10-BSTD-01

Docket number 10-BSTD-01, Oct. 13th, 14th 2011 Workshop Comments to the California Energy Commission by Mike Gabe on the Initial Draft Language of the 2013 Standards

TABLES 140.3-A and B: Fenestration Values

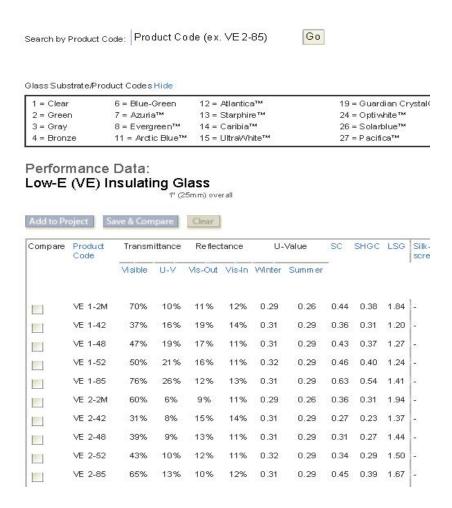
As Gary Farber has correctly pointed out, "Windows" should be listed as "Vertical Glazing".

My research shows that the category called "Glazed Doors" is too broad, and should be subdivided into "Swinging Doors" and "Sliding Doors". I cannot find any metal thermally broken sliding doors that meet the listed U-factor of 0.45, but only a value of 0.51. Is it the intention of the Commission to disallow any kind of metal sliding doors from using a prescriptive approach? If so, then the table is okay. Otherwise, for new construction:

- U-factors seem achievable with the best metal thermally broken frames.
- SHGC ("Max RSHG") values <u>are barely achievable</u> with a <u>very limited percentage</u> of the best metal thermally broken frames, based on the research I've done on the NFRC web site and looking at manufacturers' data such as that by Kawneer. More plausible prescriptive SHGC values would be to set the value to 0.27 for all these

categories, which implies a COG value of 0.27 (i.e., triple silver low-e visually clear with a high VT) and any thermally broken metal frame that does not degrade the COG value. Even this relatively minor adjustment will result in enormously better fenestration performance than current standards as the following graphics – based on the CEC draft values – illustrate (see Appendix to Gabel Comments).
